SALEM NUCLEAR GENERATING STATION, UNIT NO. 1

AMENDMENT TO FACILITY OPERATING LICENSE

Amendment No.30
License No. DPR-70

ATTACHMENT TO LICENSE AMENDMENT NO. 30

Figure B 3/4 2-1 TYPICAL INDICATED AXIAL FLUX DIFFERENCE VERSUS THERMAL POWER

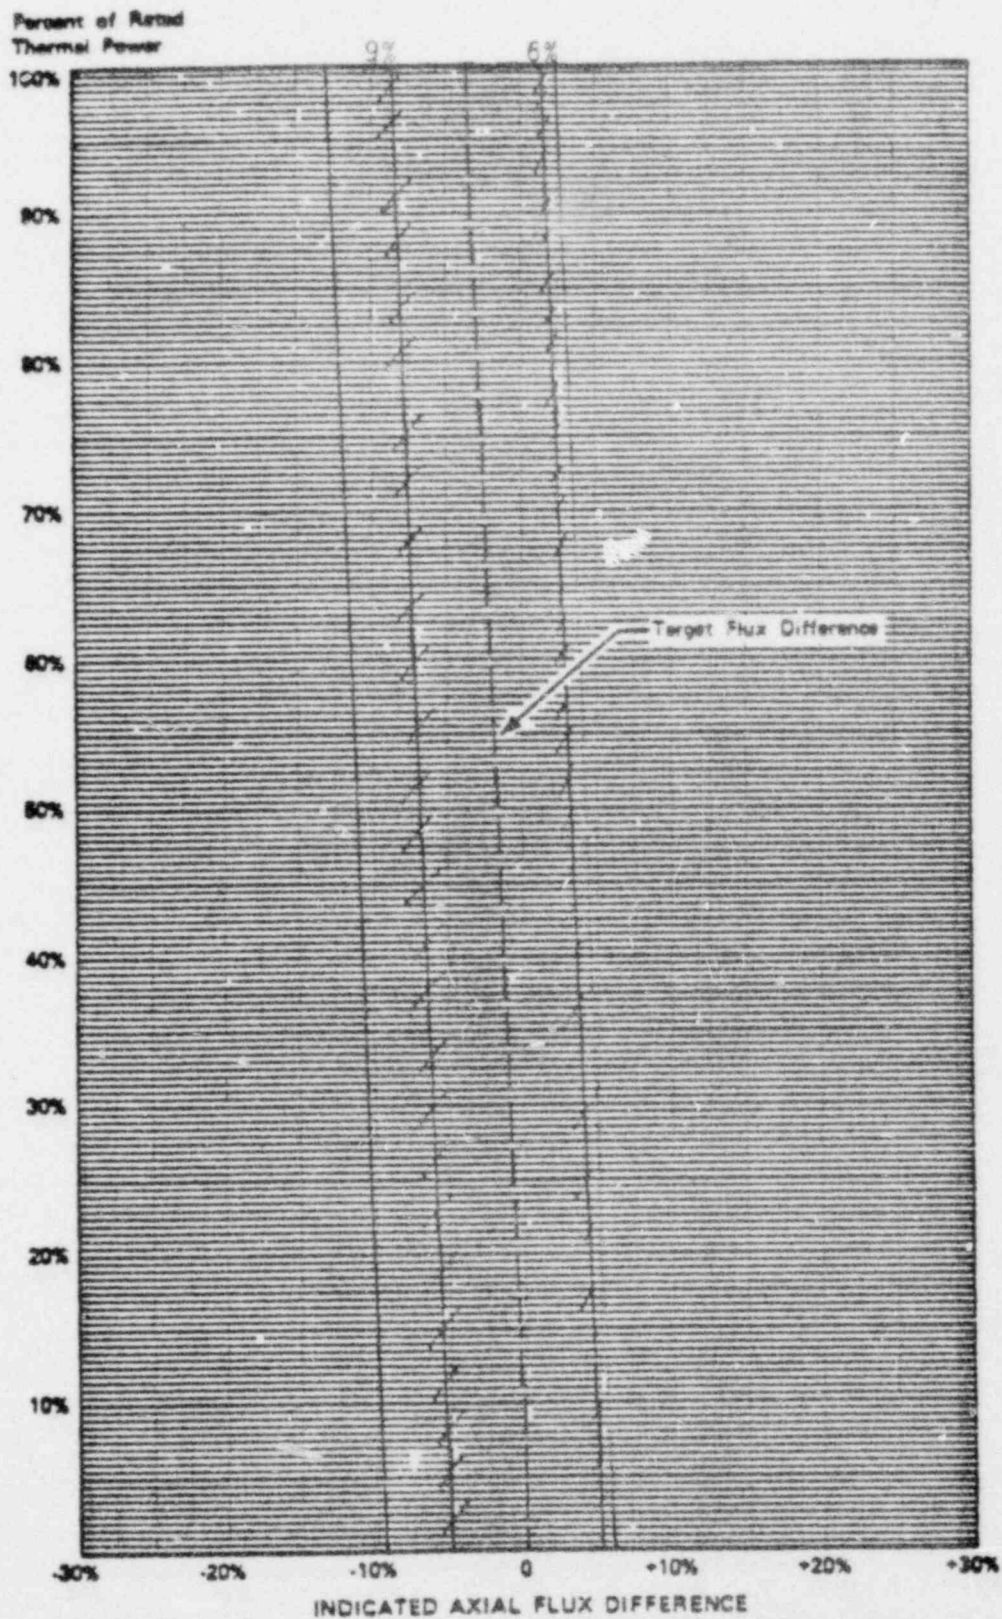
Although it is intended that the plant will be operated with the AXIAL FLUX DIFFERENCE within the +6, -9% target band about the target flux difference, during rapid plant THERMAL POWER reductions, control rod motion will cause the AFD to deviate outside of the target band at reduced THERMAL POWER levels. This deviation will not affect the xenon redistribution sufficiently to change the envelope of peaking factors which may be reached on a subsequent return to RATED THERMAL POWER (with the AFD within the target band) provided the time duration of the deviation is limited. Accordingly, a 1 hour penalty deviation limit cumulative during the previous 24 hours is provided for operation outside of the target band but within the limits of Figure 3.2-1 while at THERMAL POWER levels between 50% and 90% of RATED THERMAL POWER. For THERMAL POWER levels between 15% and 50% of rated THERMAL POWER, deviations of the AFD outside of the target band are less significant. The penalty of 2 hours actual time reflects this reduced significance.

Provisions for monitoring the AFD are derived from the plant nuclear instrumentation system through the AFD Monitor Alarm. A control room recorder continuously displays the auctioneered high flux difference and the target band limits as a function of power level. A first alarm is received any time the auctioneered high flux difference exceeds the target band limits. A second alarm is received if the AFD exceeds its allowable limits for a cumulative time of one hour during any 24 hour time period starting with the occurrence of the first alarm. Time outside the target band is graphically presented on the strip chart.

Figure B 3/4 2-1 shows a typical monthly target band.
